LEGEND		PROJECT INFORMATION	
---	EXISTING GAS LINE	PROJECT:	OIL CHANGE FACILITY
---	EXISTING SANITARY SEWER LINE		JOSEPH CADLE SURVEY, ABSTRACT NO 65
---	EXISTING STORM SEWER LINE		& WILLIAM BARNES SURVEY, ABSTRACT NO 25
---	EXISTING WATER LINE		STEEGER TOWNE CROSSING, PHASE II
---	EXISTING EDGE ASPHALT PAVING	OWNER:	THE CAMBRIDGE COMPANIES, INC.
---	EXISTING OVERHEAD POWER LINE	APPLICANT:	MARLYN ROBERTS
---	EXISTING CHAINLINK FENCE		972-771-5342
---	EXISTING WOOD FENCE	LOCATION:	HIGHWAY 205 AND RALPH HALL PARKWAY
---	EXISTING BARBED WIRE FENCE		ROCKWALL, TEXAS
---	EXISTING WROUGHT IRON FENCE	ARCHITECT:	MATTHEW KING AIA
○	POWER POLE		ROCKWALL, TX. 75087
○	1/2" IRON ROD FOUND		PH: 972-772-7995
○	5/8" IRON ROD SET	DATE:	APRIL 15, 2005
○	1" IRON PIPE FOUND		SITE PLAN ISSUE: MAY 20, 2005
□	FENCE POST CORNER		RESUBMIT: JUNE 8, 2005
□	"X" FOUND IN CONCRETE		PERMIT ISSUE: JULY 28, 2005
▲	UNDERGROUND ELECTRIC		CITY REVISIONS: DECEMBER 7, 2005

SITE PLAN **SP-1**

1 site plan
1" = 20'

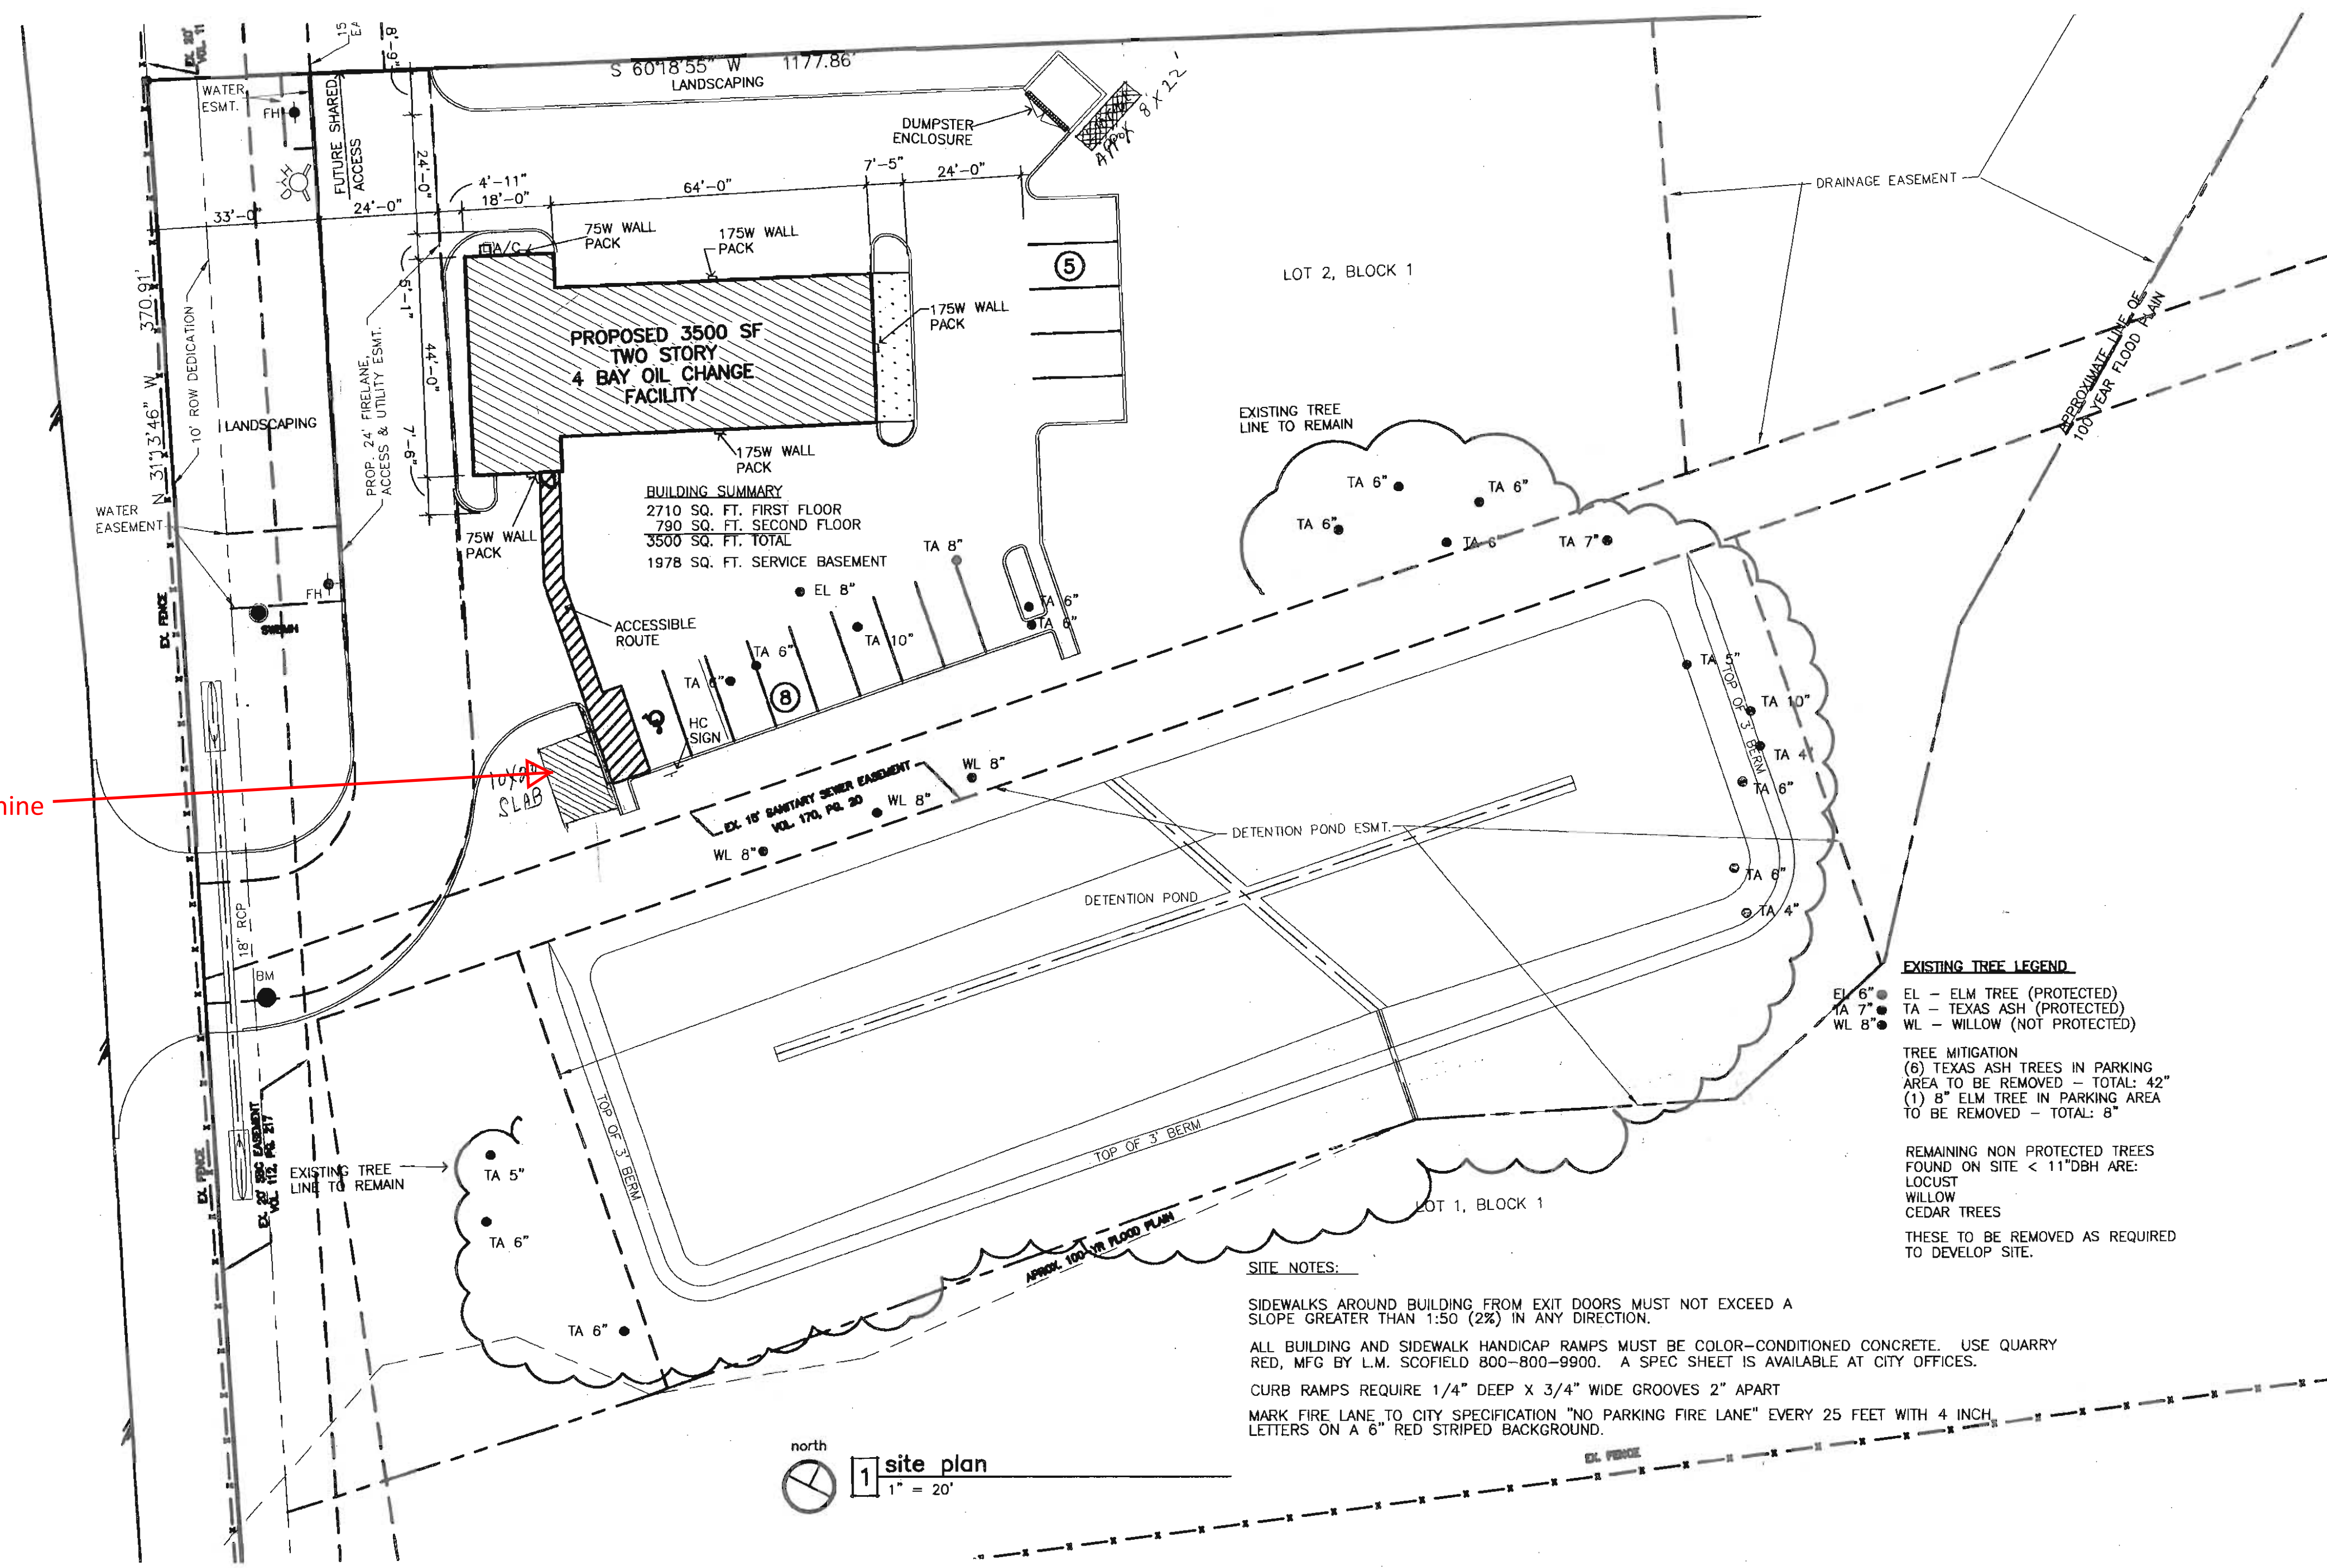
Location of Ice Machine

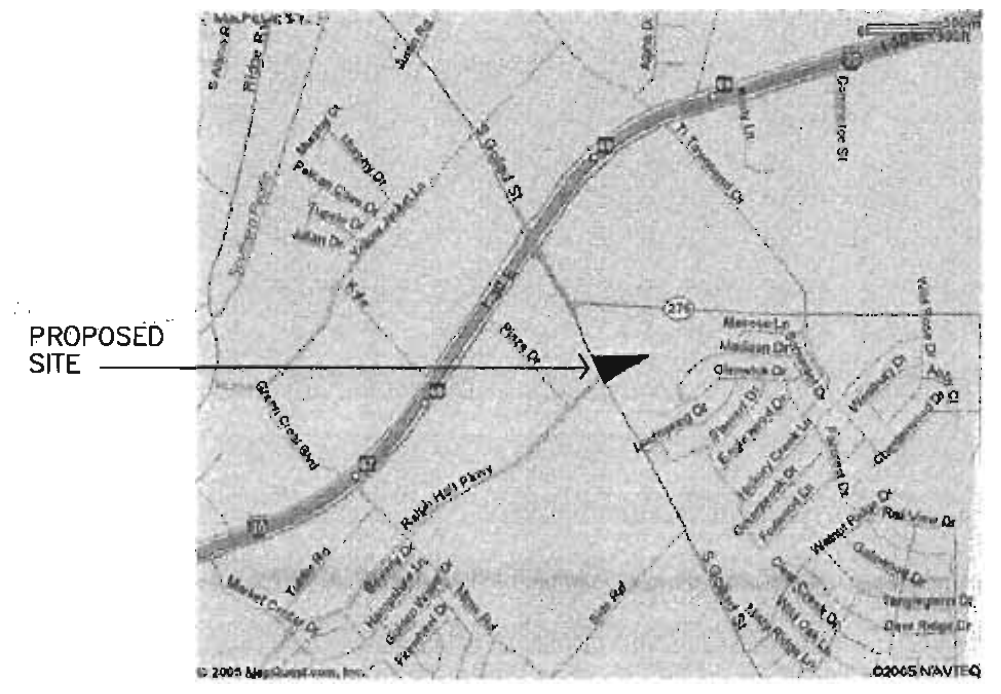
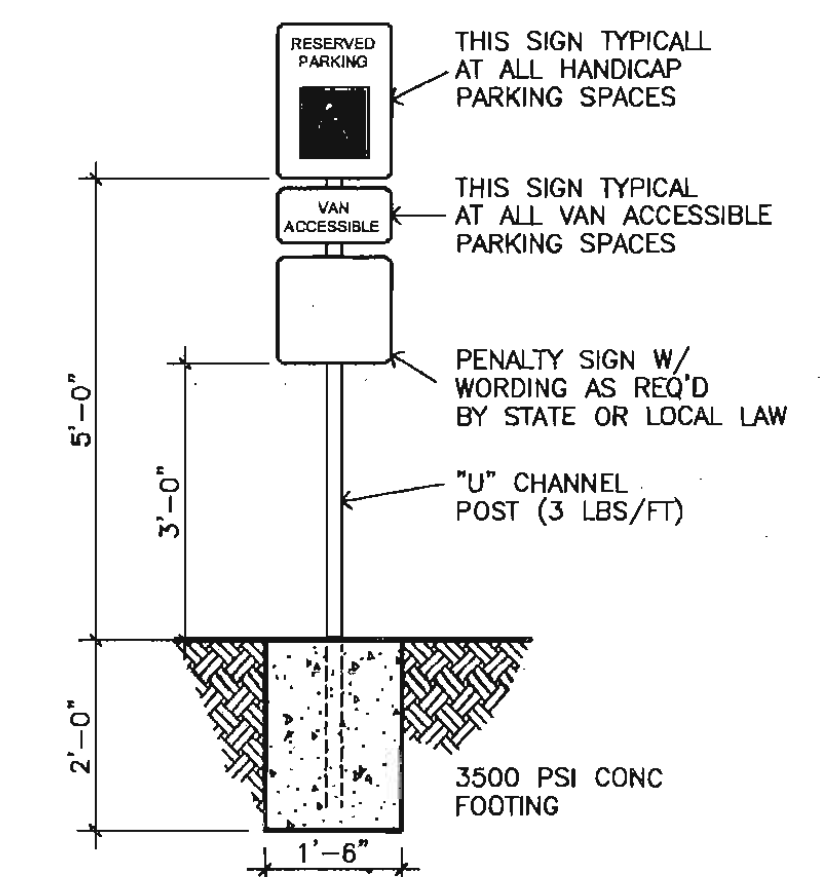
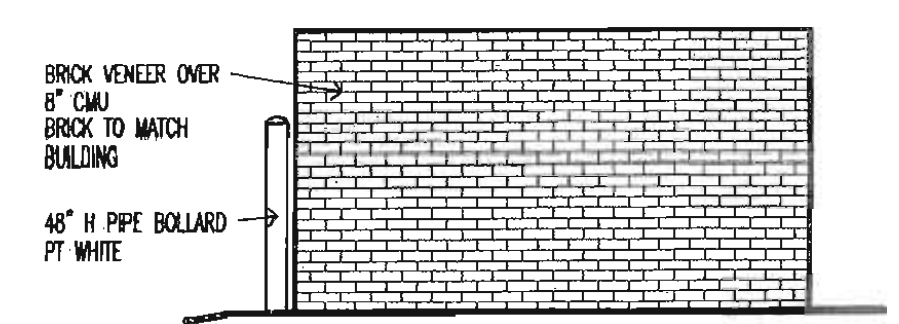
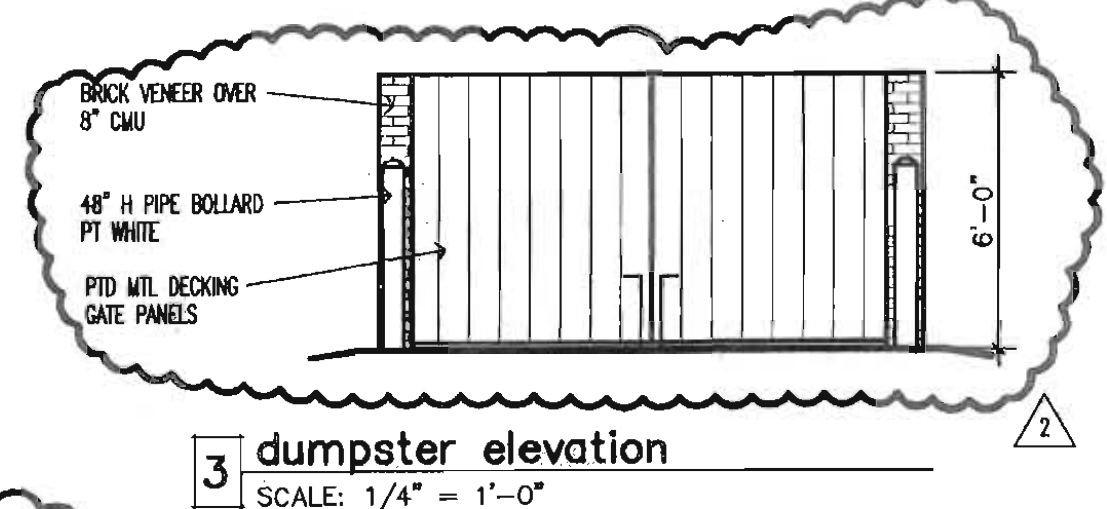
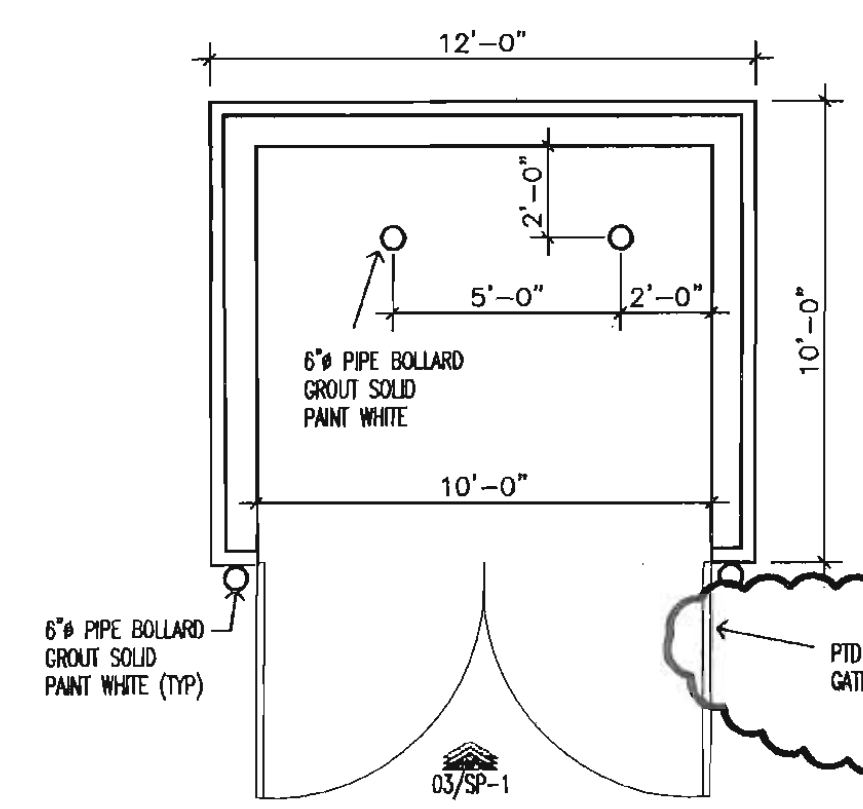
NOTE: The roof should be standing seam metal as was indicated by the applicant at the meeting where this case was approved.
